**City of Portland, Maine - Building or Use Permit Application**  
 389 Congress Street, 04101 Tel: (207) 874-8703, Fax: (207) 874-8716

Permit No: 01-0728 Issue Date: JUL - 6 2001 CBI: 309 F005001

<b>Past Use:</b> Single Family	<b>Proposed Use:</b> Same: Build a 9' X 10' Addition to be used as a mudroom. Call Jimat 854-2424 when ready.	<b>Permit Fee:</b> \$66.00	<b>Cost of Work:</b> \$7,000.00	<b>CEO District:</b> 1
<b>Proposed Project Description:</b> Build a 9' X 10' Addition for a Mudroom.		<b>FIRE DEPT:</b> <input type="checkbox"/> Approved <input type="checkbox"/> Denied <b>INSPECTION:</b> Use Group: <b>513</b> Type: <b>513</b> <b>PERMIT ISSUED WITH REQUIREMENTS 08/1997</b> Signature: <i>[Signature]</i>		
		<b>PEDESTRIAN ACTIVITIES DISTRICT (P.A.D.)</b> Action: <input type="checkbox"/> Approved <input type="checkbox"/> Approved w/Conditions <input type="checkbox"/> Denied Signature: _____ Date: _____

BUILDING PERMIT REPORT

Sec. 14-428. Corner lots.

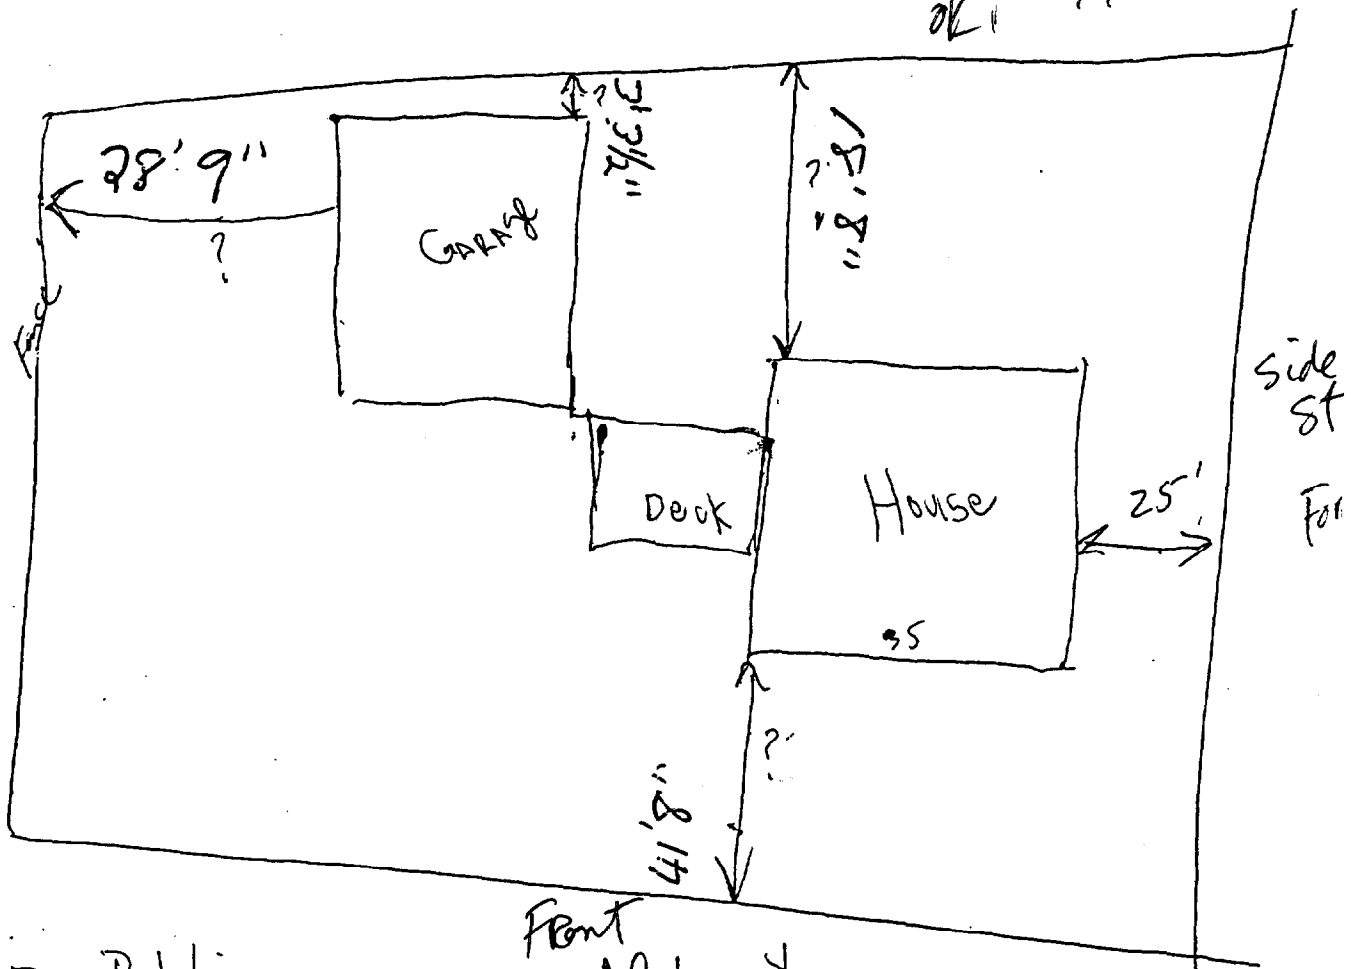
Existing facing long side- aggregate of yards	Required setbacks if facing on short side
Front yard <del>41.6</del> feet	Front yard 25 feet
Rear yard 3.25 feet	Rear yard 25 feet
Side yard -rt 25 feet	Side yard -rt 8 feet
Side yard -lft <del>28.75</del> feet	Side yard -lft 20 feet

TOTALS ~~98.66~~ feet is greater than 78 feet  
 98.66 ← OK → 78 feet

received back  
 ok 7/5/01

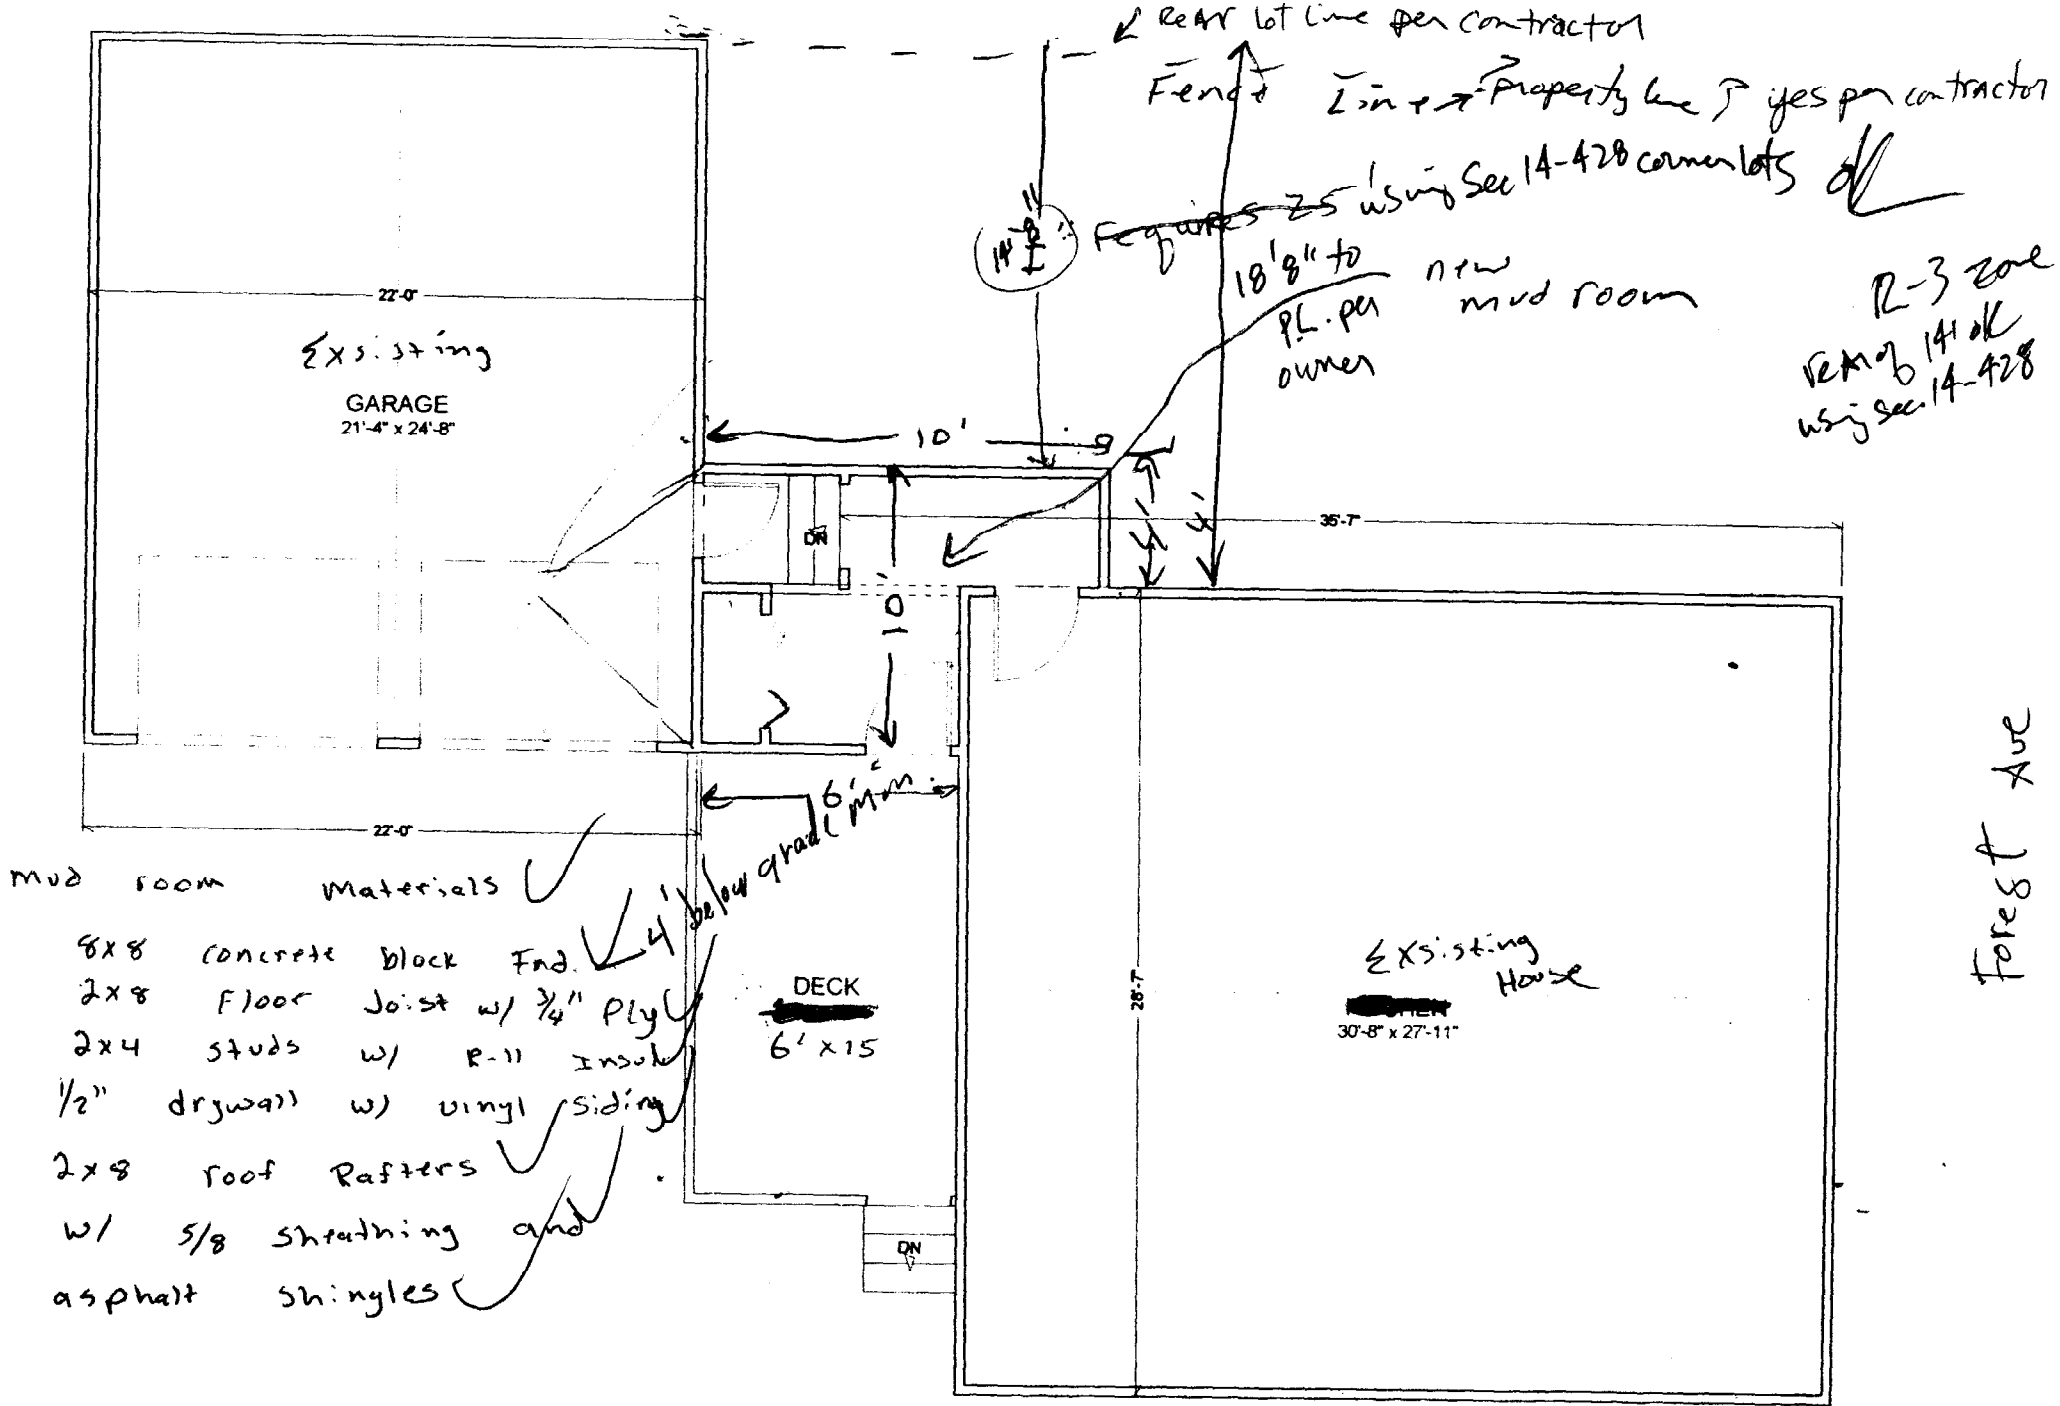
← Rear lot line per contractor  
 Fence Line → Property line ✓ yes per contractor

Requires 25' using Sec 14-428 corner lots ok  
 18 1/8" to PL. per owner  
 new mud room

R-3 zone  
 Rem of 14' ok  
 using Sec. 14-428
